YARRA CITY COUNCIL
Internal Development Approvals Committee
Agenda

**to be held on Wednesday 24 October 2018 at 6.30pm
in Meeting Rooms 1 & 2 at the Richmond Town Hall**

Item		Page	Rec. Page
1.1	PLN17/0959 - 1E Marine Parade, Abbotsford - Use and development of the land for the construction of a mixed use building (permit required for office and retail (food and drink premises) uses) and a reduction in car parking requirements.	5	34

-
- 1.1 PLN17/0959 - 1E Marine Parade, Abbotsford - Use and development of the land for the construction of a mixed use building (permit required for office and retail (food and drink premises) uses) and a reduction in car parking requirements.**
-

Figure 2 – amended plans

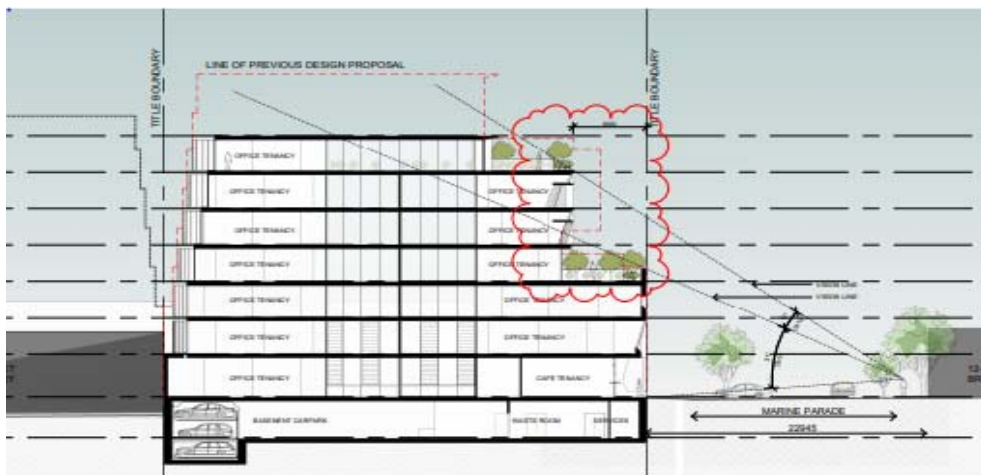
115. This outcome is evident in the following images (advertised plan images below in figure 1), with the previously proposed building envelope illustrated in red (figure 2). These images demonstrate how massing, articulation and changes in surface treatment have been utilised to relate the taller building to the surrounding scale, as recommended in Clause 22.10-3.3 of the Scheme.

116. The following image, along with the previous perspectives, demonstrate that floor 3 and 6 would not be visible from the opposite side of Marine Parade allowing for the building to present as five stories within this view shed. The increased level 4 and 5 setbacks have also been critical in reducing visual bulk and massing issues when viewed from the street, allowing for the upper levels to appear as highly recessive element.

Figure 1 – shows NRZ located within 1.8m of the site

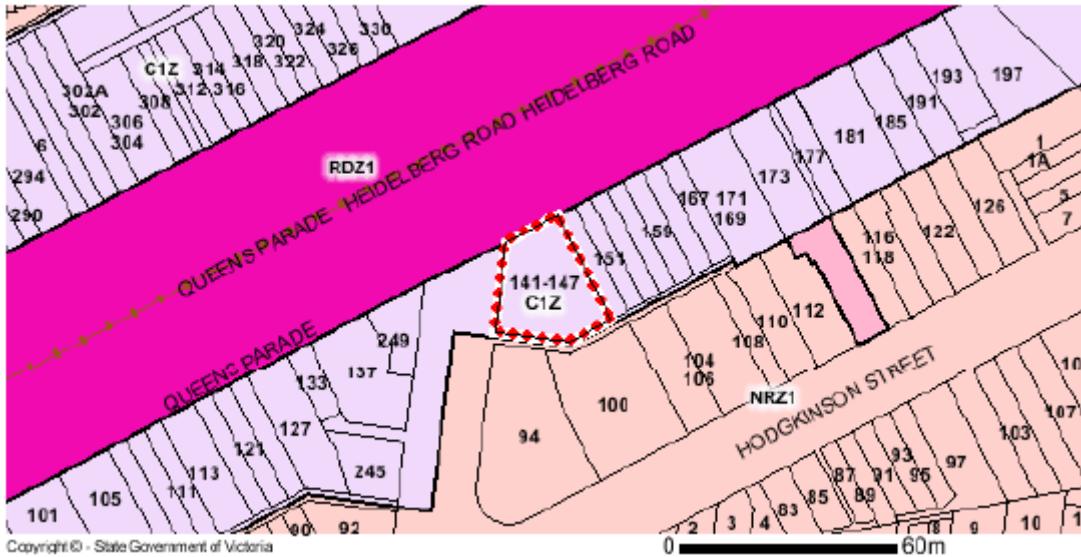
55. Properties to the south of the site are residential and a place of worship associated with St Mark's Church, all of which front Hodgkinson Street. All are located within the Neighbourhood Residential Zone.

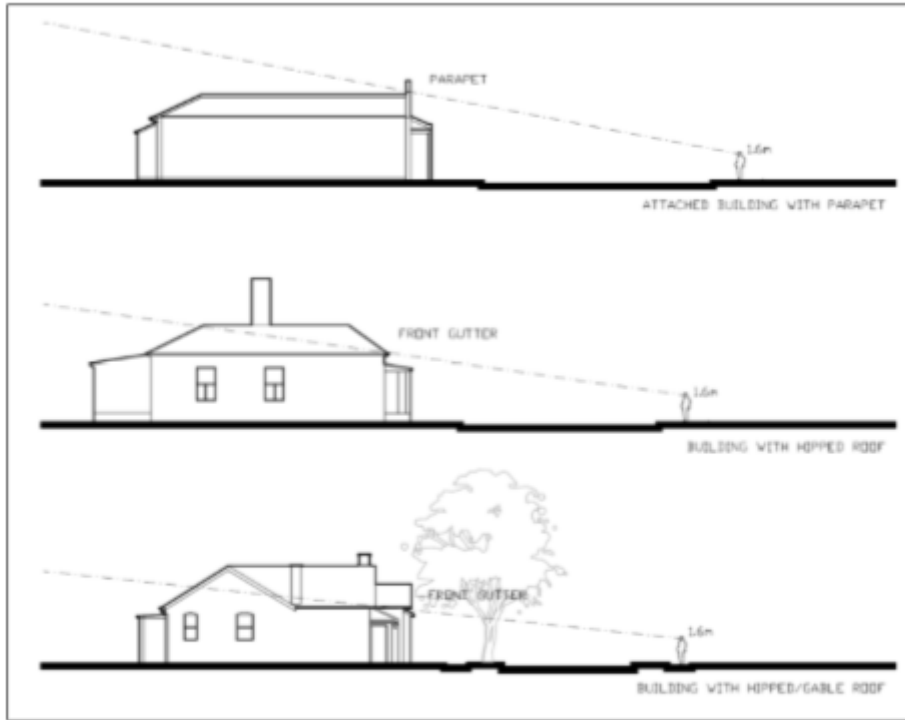
- 54. Clearly the upper level of the proposal will meet this policy as the addition will be lower than the existing building, and therefore not visible from the opposite side of the street. Similarly the first floor addition is setback from the southern boundary a minimum of 2.47m, which is greater than the existing 0.7m setback. The proposed first floor addition will therefore be concealed when viewed from the opposite side of the street.
- 55. The ground floor addition will also be compliant with Council’s heritage policy which allows ground floor additions to be constructed closer to the front of the site than higher elements (see below Figure 1 from clause 22.02-5.7.1 of the Scheme). With a setback of over 19m behind the retained façade of the building, the proposal has been sensitively designed to minimise the impacts of the development on the heritage character of the street.

Figure 1 acceptable areas for ground level additions are sited within the area created by drawing a 45 degree view line from the opposite footpath through the front corner of the subject building and the corners of adjacent buildings.

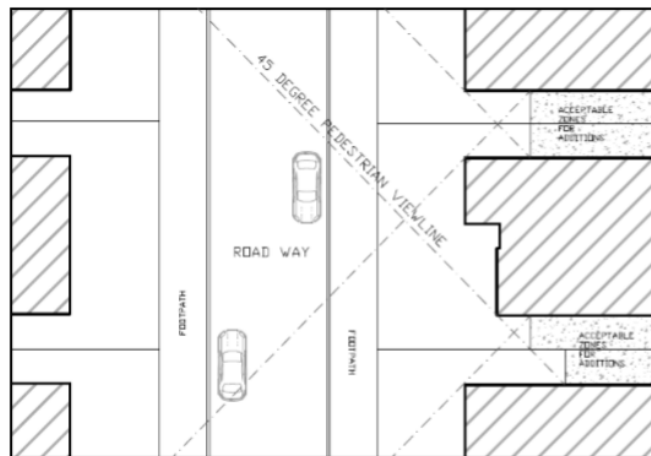
56. The proposed additions, will effectively replace an existing double storey built form to the rear of the existing dwelling. The addition incorporates a flat roof form which is setback approximately 20m from the front boundary (the remainder of the addition is setback over 25m from the front boundary). The addition has a maximum height of 7.6m (lift core), with an average height of 6.9m. The dwelling's footprint will increase, with additional built form along the southern boundary (ground floor laundry and butler pantry), however will maintain a minimum 1m setback from the adjoining open space at No. 45 Alfred Crescent. The ground floor setback to the rear will increase and allow for a pool and decking area, maintaining the open space area to the rear of the property and to both adjoining properties.
